Introduction

This note identifies the issues that have been considered to inform the alignment of the proposed new estate road that is required to serve the Navigator Quarter development and designed so that it could also form the first part of a future Chickenhall Lane Link Road.

PROJECT TITLE
**NAVIGATOR QUARTER,
SOUTHAMPTON**

Figure 1: Extract from Planning Policy Map (North)

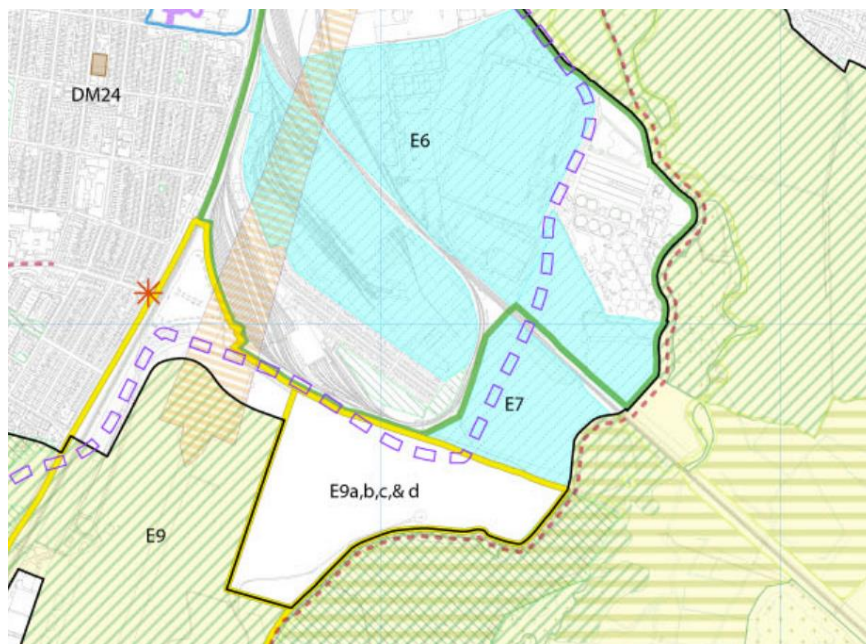
The Tree Officer also requested that the applicant *"demonstrate that the proposed route (of the estate road) is the least impactful and/or justify that the proposed route is the only option, and reasons for that"*. This note has therefore been prepared to explain the considerations taken to determine the most appropriate alignment for the estate road.

A route for the Chickenhall Lane Link Road (CLLR) has been safeguarded to ensure that this infrastructure can come forward. This safeguarded route is shown on Eastleigh BC's Planning Policy Map (North) that forms part of the adopted Development Plan, part of which is reproduced below as shown by Figure 1. This safeguarded route is shown by the dashed purple line. Policies E7 and E9 of the Local Plan states that the CLLR shall be provided *'..with an alignment as indicated on the policies map...'*. As the proposed estate road that forms part of the hybrid application will comprise the first part of the CLLR, the alignment of this safeguarded route shown on the Policies Map directly informs this application to ensure that it is in accordance with Policy E6. Using the safeguarded route to inform the application is of particular importance to ensure that this new Estate Road can connect to the other part of the safeguarded route to the north as this is effectively a fixed point.

Policies E7 and E9 allow for flexibility in the exact route of the CLLR and the proposed design of the new Estate Road is not exactly the same as the safeguarded route. The detailed design ensures that site constraints and design standards are taken into account. The specification of the CLLR was not agreed or set out in the Local Plan and the scope of this has now been reviewed with the Local Highway Authority. The alignment of the Estate Road is a sufficient geometry to allow for all potential road users, including HGV's and also accommodates an active travel route alongside it, which has informed the route set out in this planning application.

As figure 1 shows, the Council intend for the connection to Chickenhall Lane be made from the northernmost corner of the North Plot. To access this point, it is proposed that future extensions of the estate road run alongside the western boundary of the North Plot, to minimise encroachment into the developable area of the plot and enable the most efficient use of land. Were the route to connect the plots further along the tree belt, in order to reach Chickenhall Lane, the estate road would be required to diagonally cross the North Plot, splitting it into two irregularly shaped spaces, which would be less efficient to develop. This would counteract Chapter 11 of the NPPF, and specifically paragraph 129, which encourages developments to make effective use of land.
